# Access Compliance Report

## Public Rights-of-Way

### (Curb Ramps)

Intersection ID: N/A	Main Street: CRESSWIND BV	Cross Street: TREESDALE LN	Location: N
ADA ID: 7EF9A39ADBC3	Ramp Type: BlendTrans1	Initial Pass/Fail: Fail	Overall Compliance: No
		Severity Score: 1.25

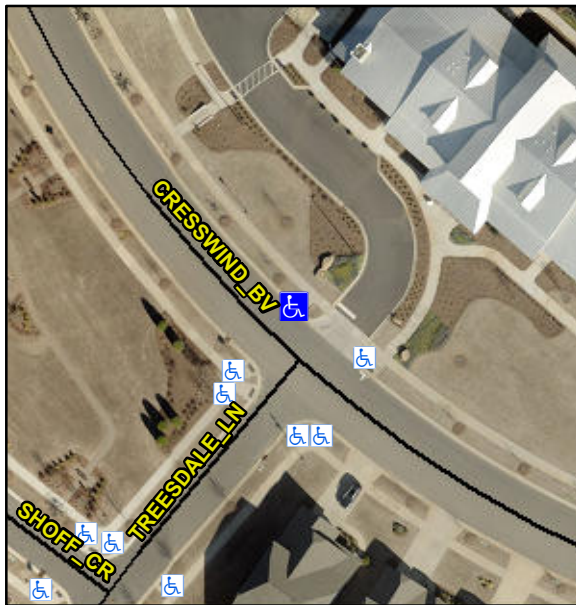
**Not Found, R304.5.3**

Compliance	Description	Data	Compliance	Description	Data
N/A	Ramp Length (in)	97.0	Yes	BlendTrans Slope (%)	4.5
Yes	Ramp Width (in)	57.0	No	BlendTrans XSlope (%)	3.4
N/A	Flare Type LT	N/A	N/A	Flare Type RT	N/A
N/A	Flare Slope LT (%)	N/A	N/A	Flare Slope RT (%)	N/A
N/A	Flare Traversable LT?	No	N/A	Flare Traversable RT?	No
N/A	Landing Length (in)	N/A	N/A	DWS Provided?	N/A
N/A	Landing Width (in)	N/A	N/A	DWS Contrast?	N/A
N/A	Landing Slope (%)	N/A	N/A	DWS Length (in)	N/A
N/A	Landing X Slope (%)	N/A	N/A	DWS Full Width?	N/A
N/A	Landing Curb? (Y/N)	N/A	N/A	DWS Offset (in)	N/A
N/A	Shared Landing?	N/A			
N/A	Gutter Ponding?	N/A	N/A	Gutter Slope (%)	N/A
N/A	Gutter Lip Ht (in)	N/A	N/A	Gutter X Slope (%)	N/A
N/A	Painted X Walk1?	No	N/A	Painted X Walk2?	N/A
	X Walk 1 Direction	To SW		X Walk 2 Direction	N/A
	X Walk 1 Width (in)	N/A		X Walk 2 Width (in)	N/A
	X Walk 1 Slope (%)	2.6		X Walk 2 Slope (%)	N/A
	X Walk 1 X Slope (%)	2.5		X Walk 2 X Slope (%)	N/A

N/A	Ramp inside XWalk1?	N/A	N/A	Ramp inside XWalk2?	N/A
	Road Slope (%)	2.5		Clear Space?	N/A
	Road X Slope (%)	2.6	N/A	Clear Space to XWalk (in)	N/A
N/A	Any Obstructions?	N/A	N/A	Storm Grate/Utility Hazard?	N/A
	Obstruction Type			Storm Grate/Utility Type	
		N/A			N/A
			Yes	Surface Condition? (G/P)	Good
			No	Curb Slope (%)	7.4

**Remove & Replace Curb Ramp With Two New Directional Ramps or Equivalent.**
